Modification Summary
GCRP 13
Thursday 9th February 2006

The following modification proposals were recommended for approval at GCRP Meeting 13 on 9th February 2006.

Figure WFPS1.3

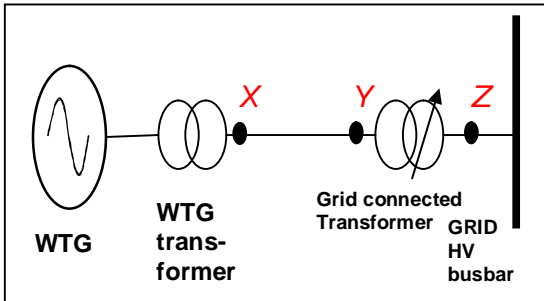
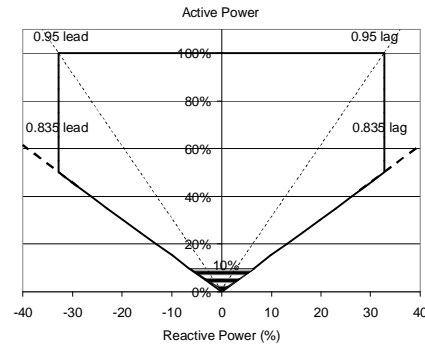
In order to avoid any confusion as to which is the reference voltage it is proposed to change the current clause *from*:

“Wind Farm Power Stations shall be capable of operating at any point within the **Power Factor** ranges illustrated in Figure WFPS1.4, as measured at the LV side of the **Grid Connected Transformer** (point Y in Figure WFPS1.3), for any **Voltage** at the **Connection Point** within the ranges specified in WFPS1.6.1”

Wind Farm Power Stations shall be capable of operating at any point within the **Power Factor** ranges illustrated in Figure WFPS1.4, as measured at the lower **Voltage** side of the **Grid Connected Transformer** (point Y in Figure WFPS1.3).

The design reference **Voltage** for the reactive power capability shall be the nominal **Voltage** at point Y.

The **Grid Connected Transformer** tap changing range must be capable of ensuring nominal **Voltage** at point Y for any **Voltage** at the **Connection Point** (Point Z) within the ranges specified in WFPS1.6.1.
